STATE OF NEW YORK
OFFICE OF GENERAL SERVICES
DESIGN AND CONSTRUCTION GROUP
THE GOVERNOR NELSON A. ROCKEFELLER
EMPIRE STATE PLAZA
ALBANY, NY 12242

ADDENDUM NO. 2 TO PROJECT NO. 45097

**CONSTRUCTION WORK, HVAC WORK, PLUMBING WORK, AND ELECTRICAL WORK
PROVIDE DAY CARE CENTER
BUILDING NO. 3
STATE OFFICE BUILDING CAMPUS
1220 WASHINGTON AVENUE
ALBANY, NY**

June 10, 2015

DWG NO:
A-513

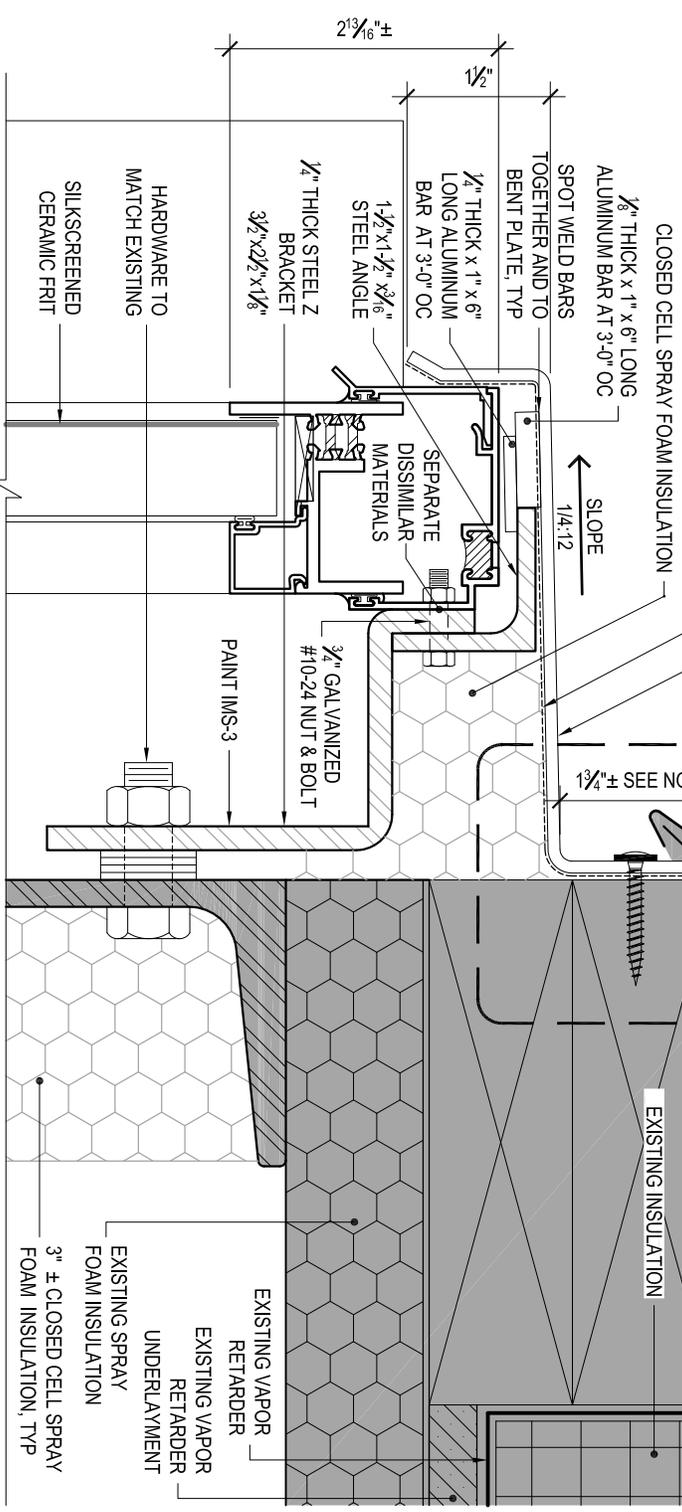
- Detail 2: Delete the portion of the window head detail above the top breaklines in its entirety. See Addendum Drawing A-513 (dated 6/10/15) for replacement Detail.

- Detail 3: Delete the portion of the window head detail above the top breaklines in its entirety. See Addendum Drawing A-513 (dated 6/10/15) for replacement Detail.

NOTE: MOCKUP #4 (1) FULL LENGTH OF BENT ALUMINUM PANEL. ADJUST HEIGHT OF VERTICAL LEG AS REQUIRED TO INSTALL WITHOUT DAMAGING EXISTING ROOF FASCIA WHILE MAINTAINING MIN 3/4" OVERLAP OF FASCIA

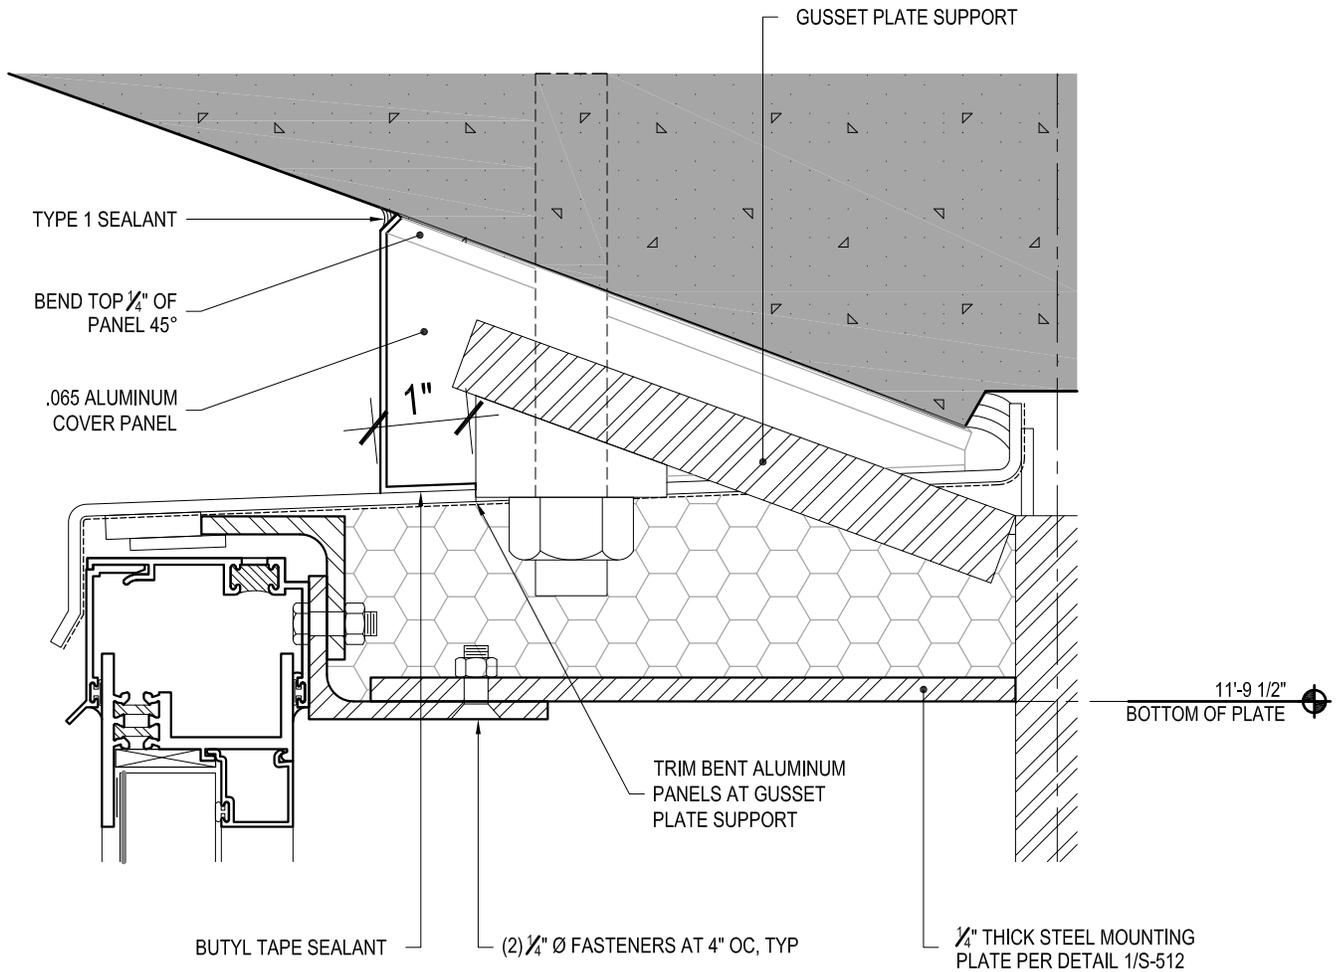
38. Drawing No. A-506, ENTRY DETAILS:
- Detail 6 GUSSET PLATE COVER PANEL: Change the detail reference number "6" to read "8".
 - Detail 9: Delete this Detail in its entirety. See Addendum Drawing A-514 (dated 6/9/15) for replacement Detail.

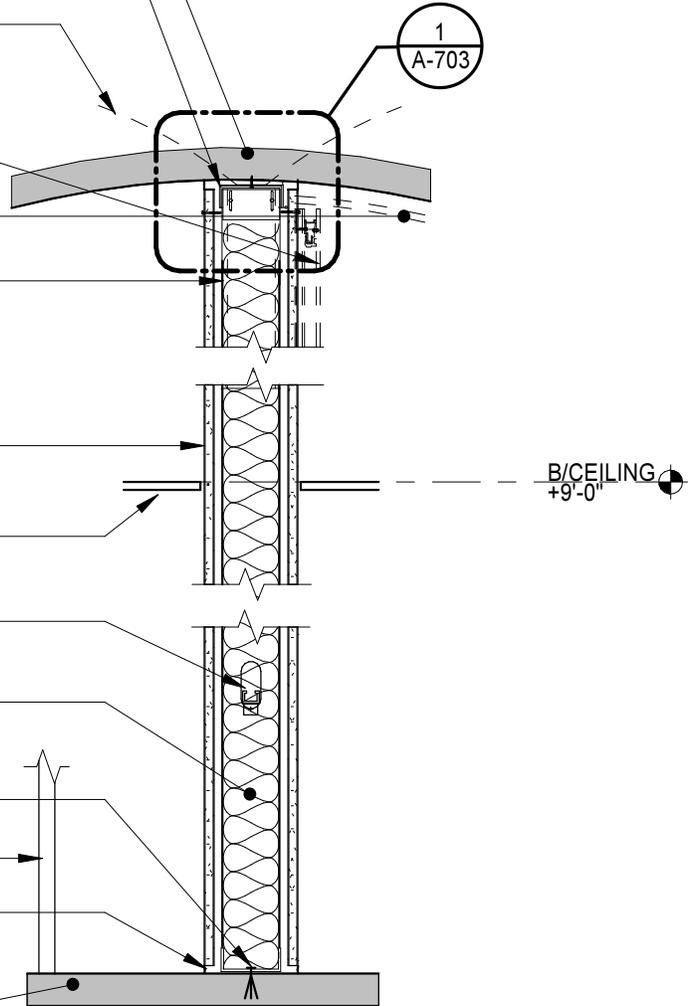
- a. Partition Type S40, noted "1-Hr Fire-Rated Shaft Wall & Ceiling at Stair 101": Delete this Detail in its entirety. See Addendum Drawing A-702 (dated 6/9/15) for replacement Detail.

43. Drawing No. A-701, PARTITION SCHEDULE:
- a. Partition Mark S40: Change the partition title designation "4" Metal CH Stud Partition" to read "1-Hr Fire-Rated 3-5/8" Metal Stud Partition".

- b. Partition Type S40: Change the description "(1) layer gwb over 1" liner board on one side and (1) layer gwb on other side. Partition transitions to rated horizontal assembly" to read "(1) layer fire-resistant gwb ea. side, partition to underside of existing deck".

- c. Partition Type S40: Change the width "4 5/8" to read "4 7/8".
 - d. Partition Type S40: Change UL Design "U415-A" to read "U465".
44. Drawing No. A-701, PARTITION TYPES:

DWG NO: C-502

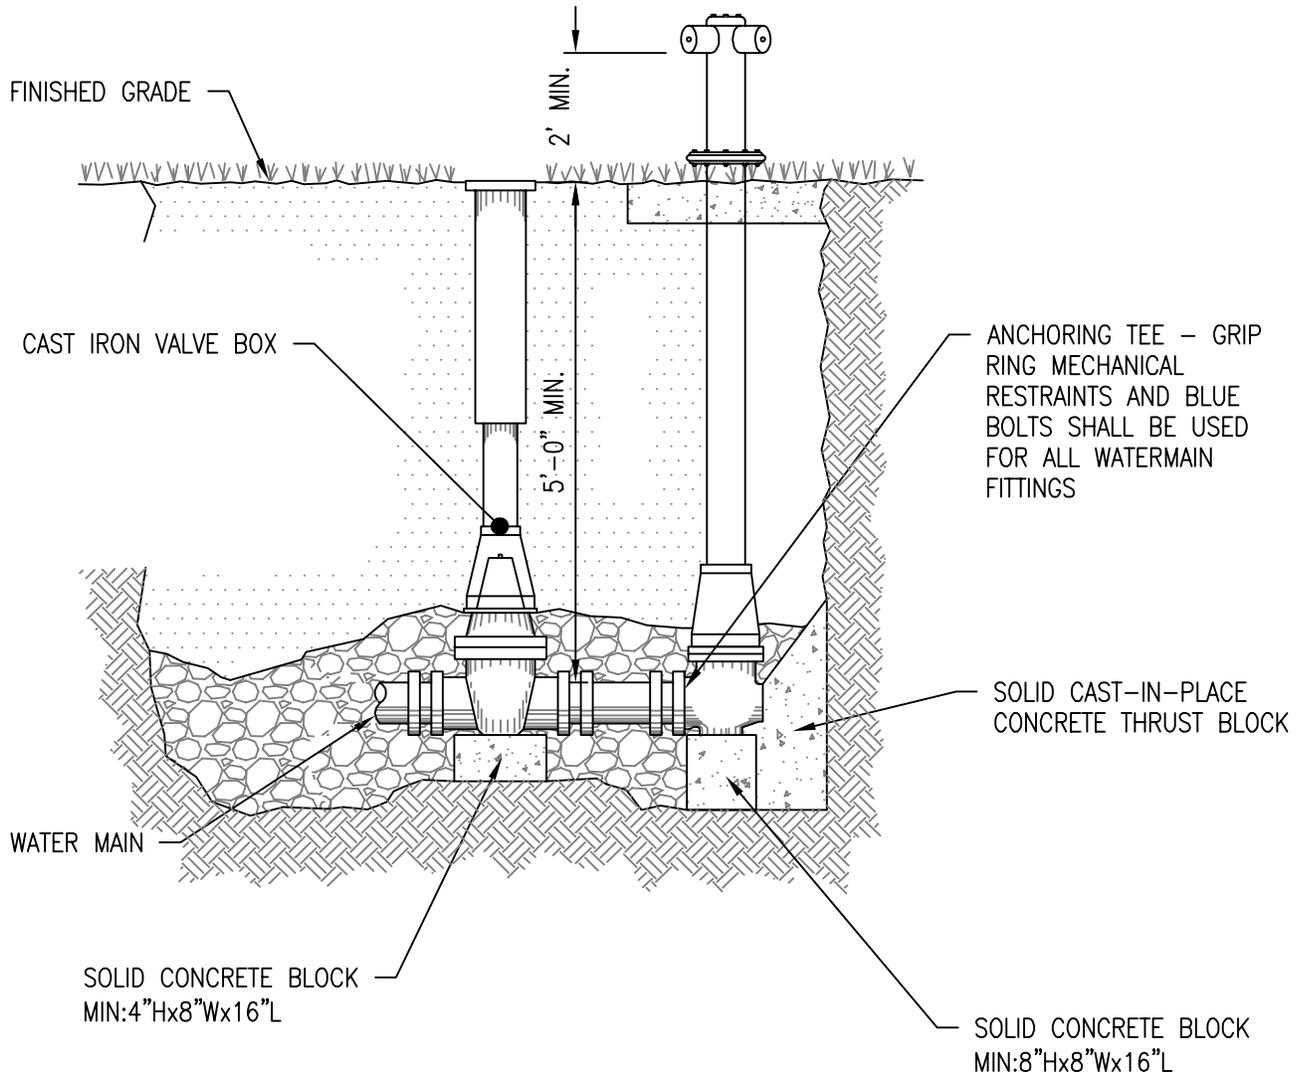
23. Drawing No. C-501, FIRE DEPARTMENT CONNECTION DETAIL:
 - a. Delete this Detail in its entirety. See Addendum Drawing C-502 (dated 6/10/15) for replacement detail.
24. Drawing No. H-101, BASEMENT GENERAL ABATEMENT PLAN:
 - a. REMOVAL KEYNOTES: Add the following Note:

SHEET TITLE: REVISION
BRACE SECTION
DETAIL

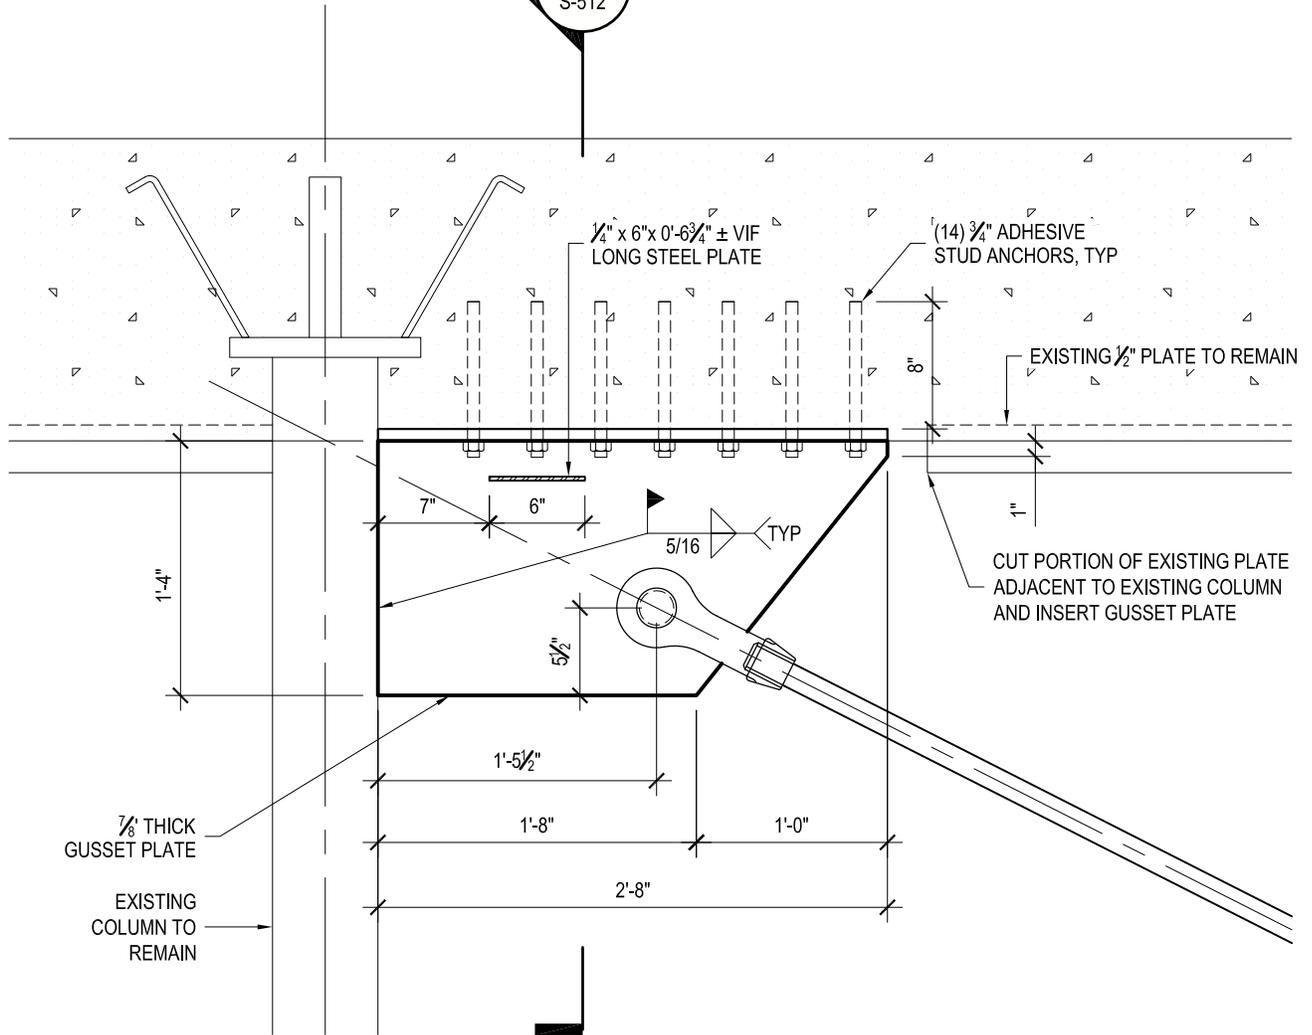
27. Drawing No. S-510, STRUCTURAL ELEVATIONS AND DETAILS:
- a. Detail 4/S-510: Delete this Detail in its entirety. See Addendum Drawing No. S-511 (dated 6/10/15) for replacement detail.

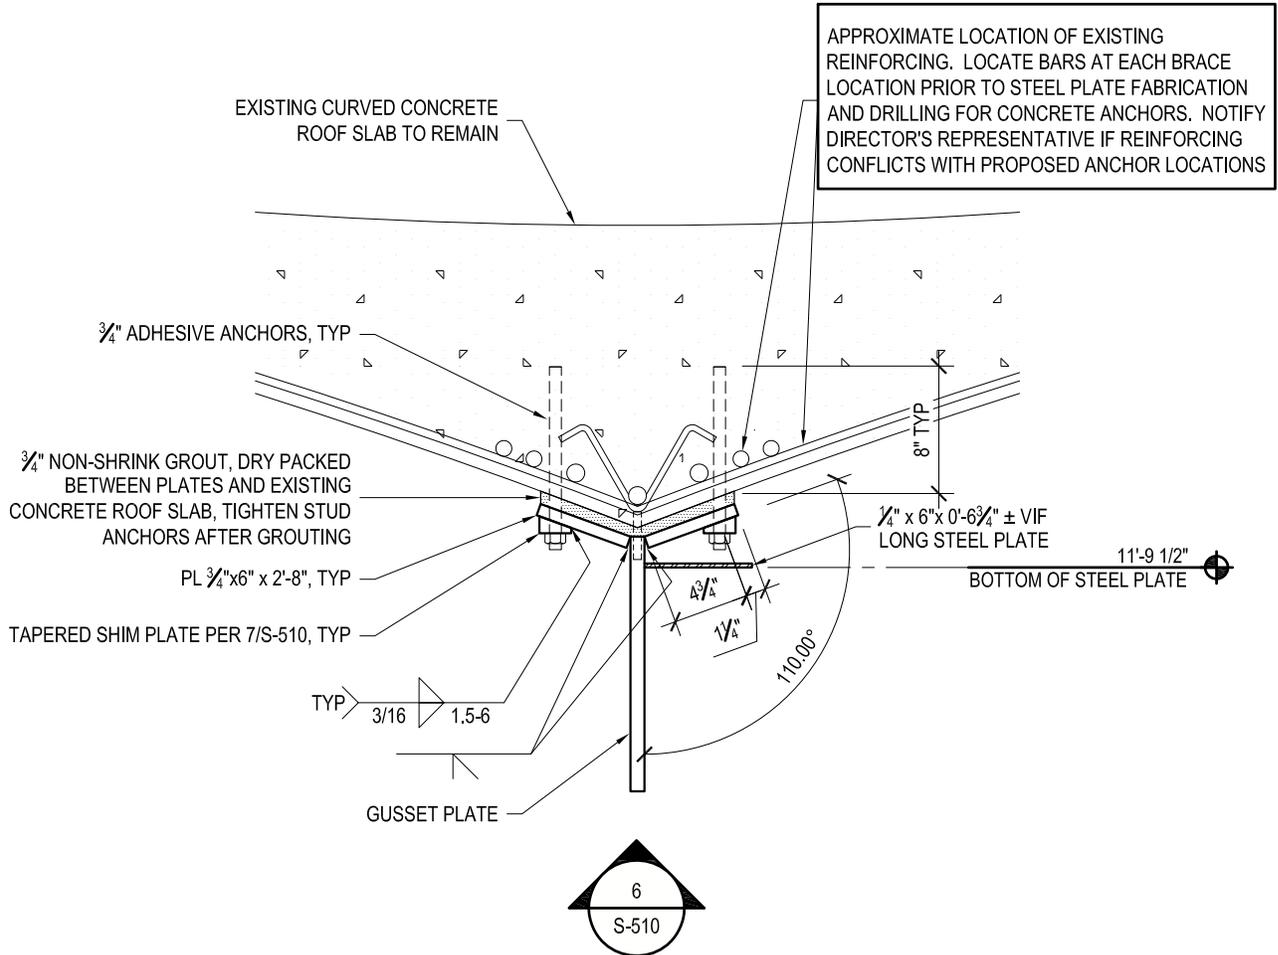
- b. Detail 5/S-510: Delete this Detail in its entirety. See Addendum Drawing No. S-512 (dated 6/10/15) for replacement detail.
28. Drawing No. A-100, REMOVAL AND REPAIR PLAN – BASEMENT::
